PLANNING COMMISSION REGULAR MEETING

Tuesday, March 19, 2024 at 7:00 PM

2. **Special Use Permit (SUP) 2023-04 W.C. Taylor Middle School**– the Applicant/Owner, Fauquier County School Board, is requesting a SUP per Article 3-4.9.3 of the Zoning Ordinance for an expansion in excess of 10,000 square feet to an existing middle school. The subject parcel is located in the Public-Semi Public (PSP) District of the Town of Warrenton Zoning Ordinance and is designated in the Greenway and Makers Character District as Public/Semi Public Non-Intensive on the Future Land Use Map. The subject parcel (GPIN 6984-48-7973-500) is located at 350 E. Shirley Avenue on approximately 39.1805 acres. The Applicant is requesting a waiver from Article 2-19 of the Zoning Ordinance to allow multiple retaining walls in excess of six feet.

TAYLOR MIDDLE SCHOOL ADDITION & RENOVATION
FAUQUIER COUNTY PUBLIC SCHOOLS
350 EAST SHIRLEY AVENUE
WARRENTON, VA 20186

SHEET
C3.01

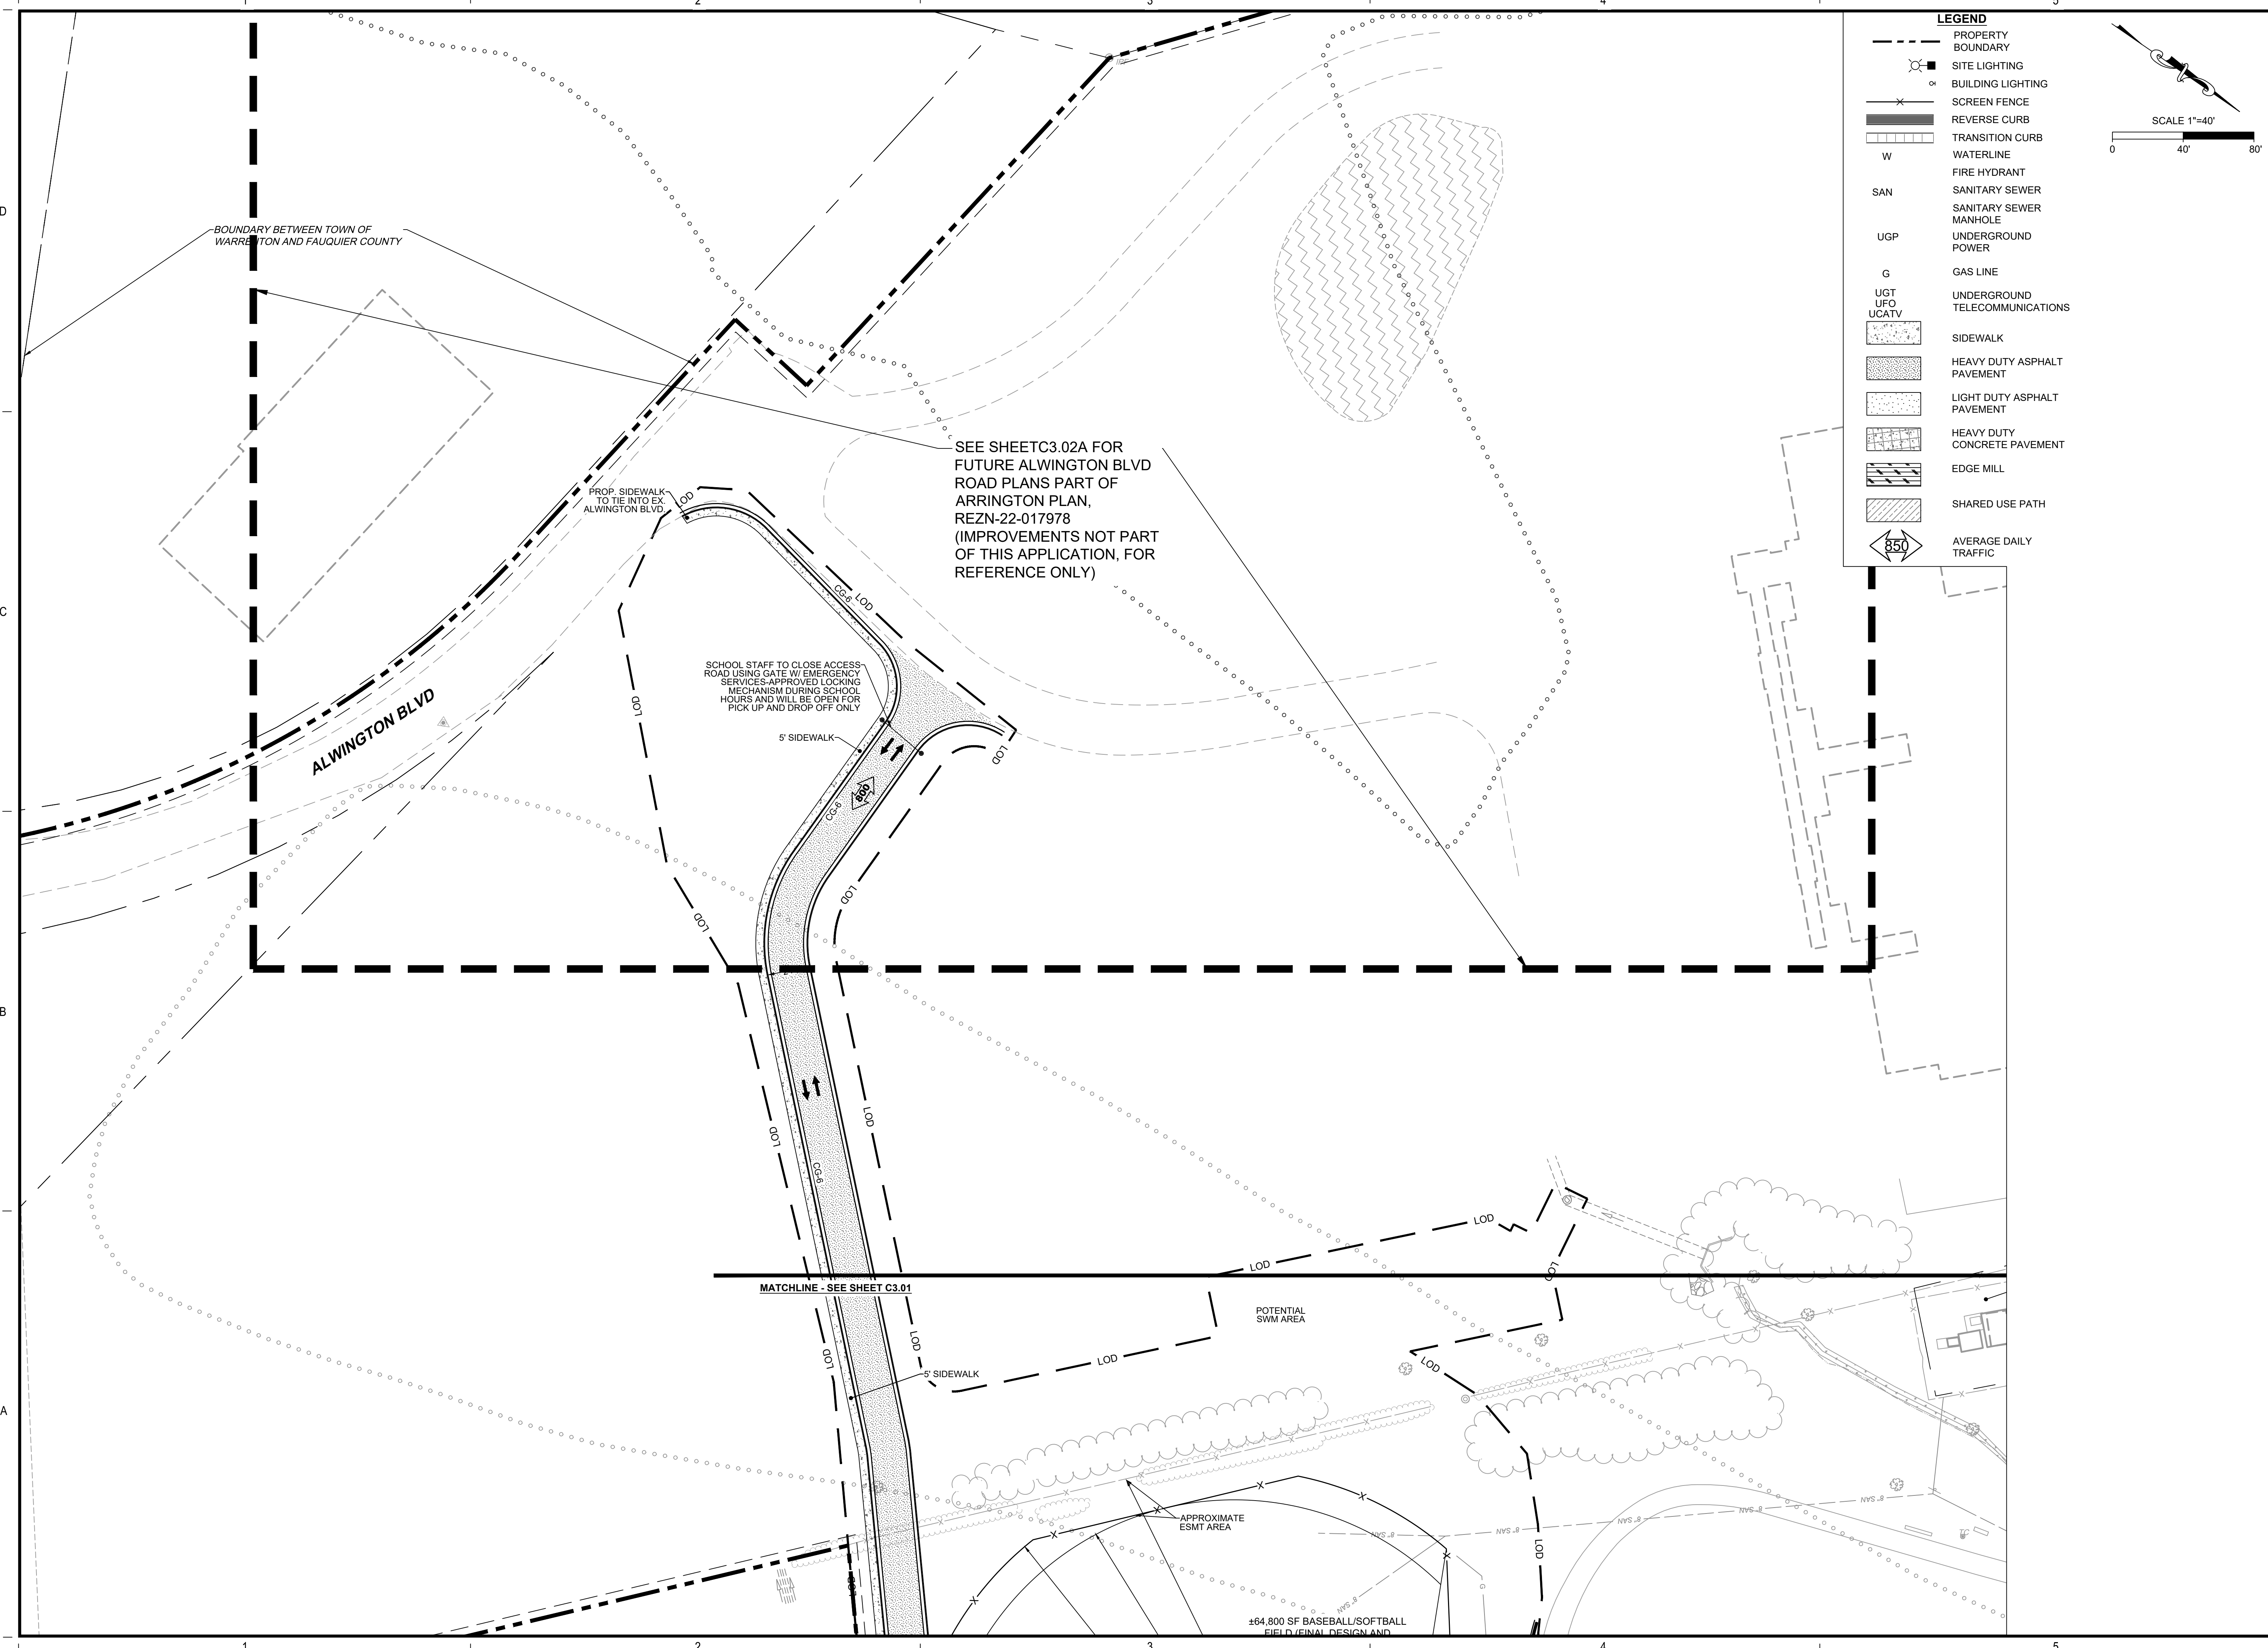
The proposed 12' retaining wall shown on the plan page C3.01 is an ongoing safety issue for a middle school campus. The presence of a 42" fence at the top, as addressed in the Timmons Group Jan. 12 letter, does not necessarily mitigate the impact of this safety issue under the circumstances presented. The justification advanced for the retaining wall in excess of 6' consists solely of (1) minimizing impact to wetlands, (2) minimize clearing on that side of the building adjacent to the proposed emergency access road, and (3) maintaining the existing gravel track and

- The special use permit plan (C3.01) shows storage lengths that are not consistent with the storage listed on page 6-4. The western entrance (Site Entrance #1) right turn has storage of 85 feet and taper of 50 feet. The northbound left turn for this entrance has 50 feet of taper length that is not

7. The special use permit plan (C3.01) shows storage lengths that are not consistent with the storage listed on page 6-4. The western entrance (Site Entrance #1) right turn has storage of 85 feet and taper of 50 feet. The northbound left turn for this entrance has 50 feet of taper length that is not included in the model. Per TOSAM, Synchro and SimTraffic models should reflect "effective storage length", which is equal to the existing striped storage length plus half of the taper length.

Response: All storage lengths have been checked and updated. The effective storage shown on Figure 2-1, Figure 5-1, the LOS tables, and the Synchro analysis files all match with the revisions.

Response: The CG-12 at the connection to Shirley Ave. has been revised to a width of 10'. See sheet C3.01.
